Riverside @ Tea Gardens

**Modification to the Concept
Plan for Concept Approval
Number 10-0136**

October 2016

Reference 213366 – R001007 Modified Concept Plan

Figure 12 – Proposed Intersection Treatment at Toonang Road

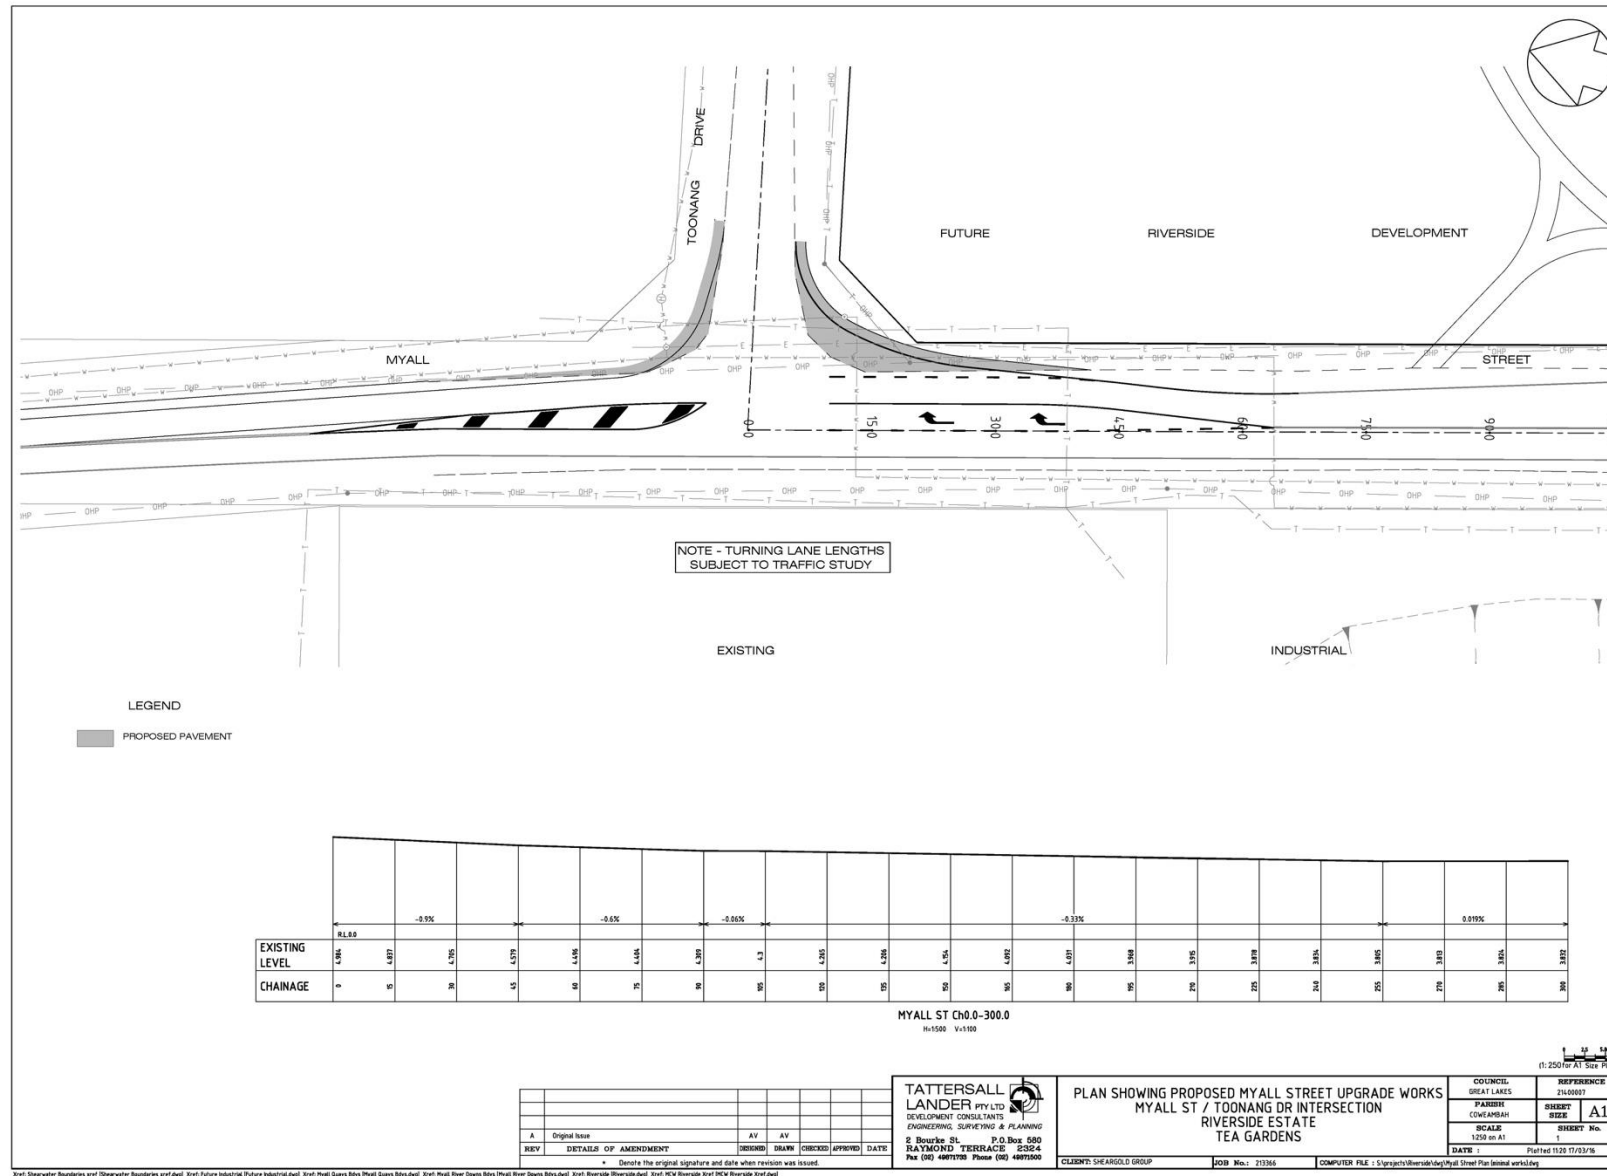
The intersection geometry of Toonang Drive has been confirmed by Council and is shown in Figure 12 below. Matters relating to the timing of the intersection in relation to the development staging works have been addressed above.

Figure 14 – Areas of Difference between approved DoP and the MCP Layouts

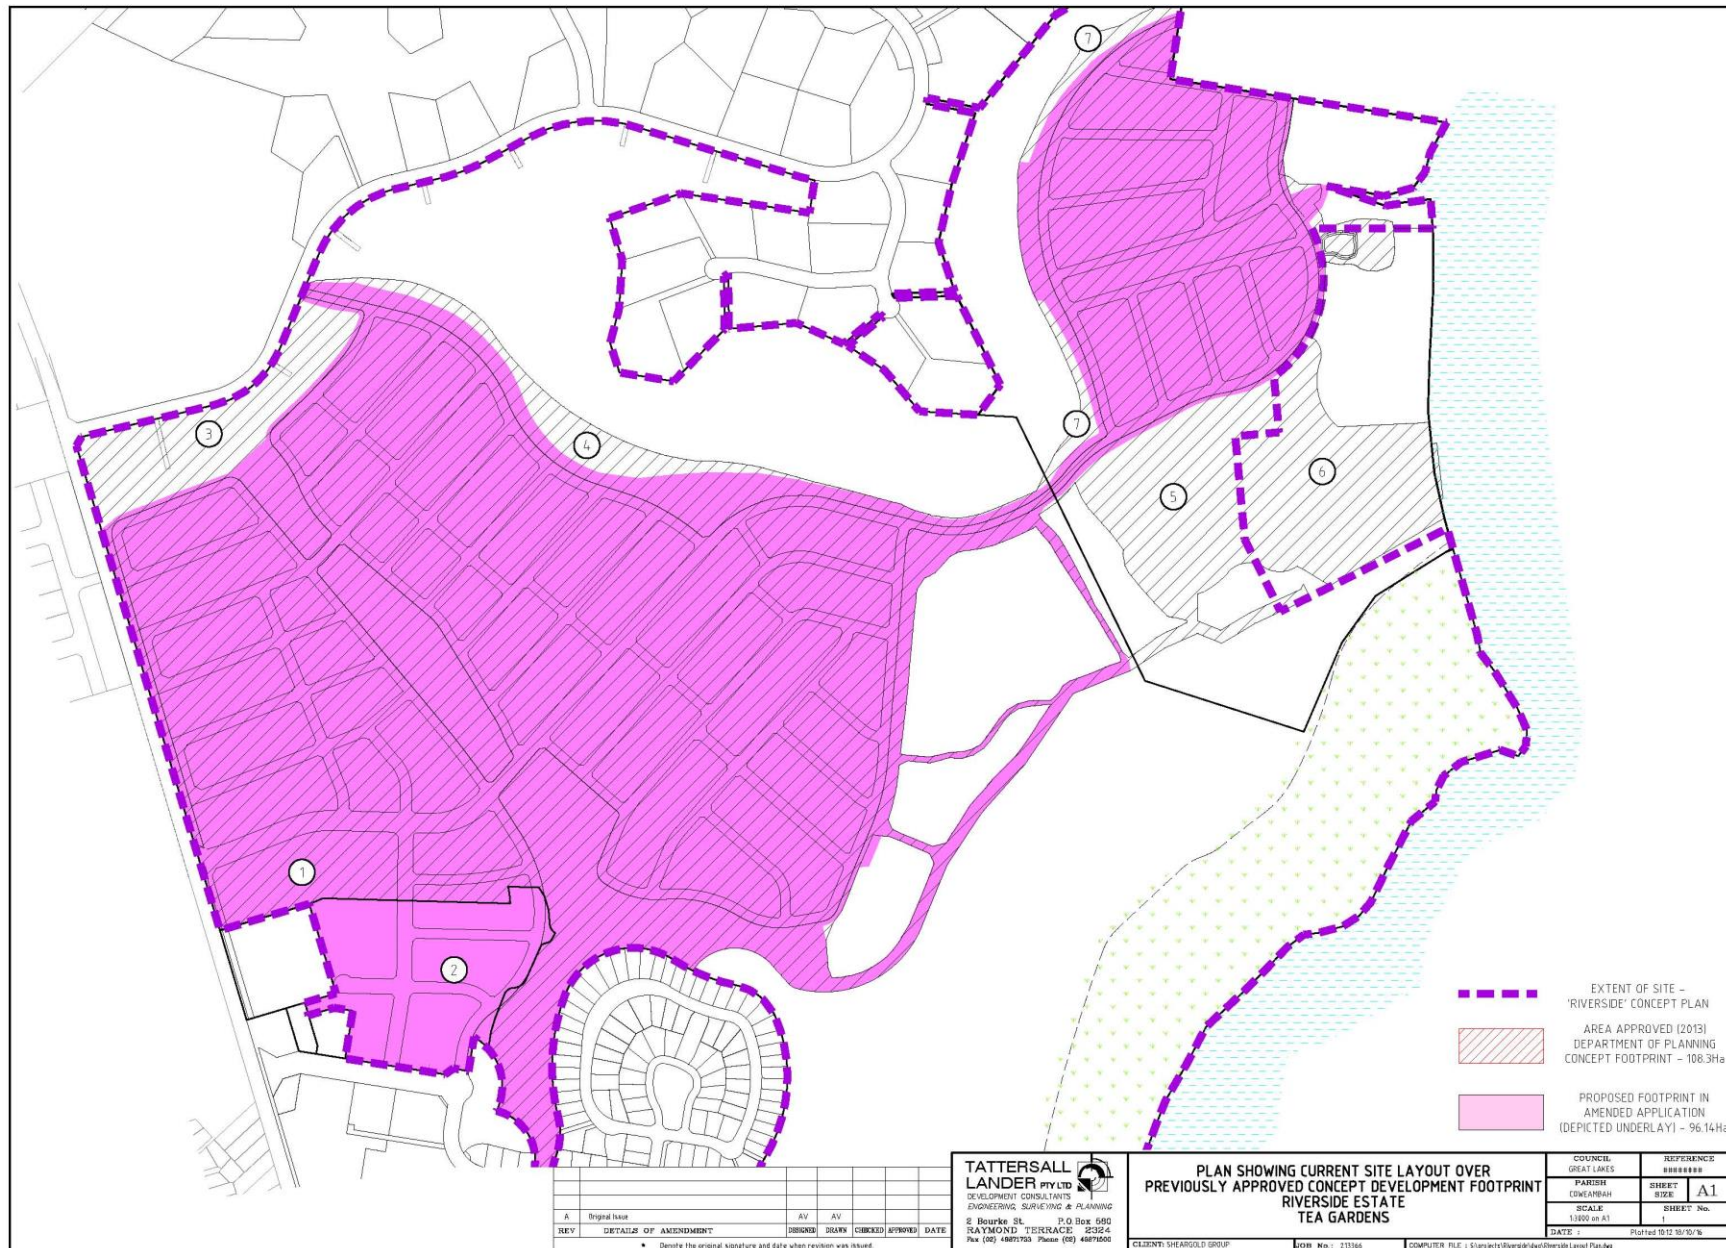
The key areas of variation between the final MCP and DoP approved development footprints highlighted on Figure 14 are:

- Area 2 – An area of residential development that has been added to the development site following discussions with Council over the commercial operations of the Village Centre. The proposed changes to the commercial and residential layout in this location has generally retained the same total areas for both commercial and residential activities and the use of lands adjoining an extension of Shoreline Drive would see development naturally extend into the project area along an infrastructure corridor.

- reduce the development area along the east-west corridor (referred to as Areas 3 & 4 on Figure 14) to maintain a wider corridor than that proposed by the DoP.
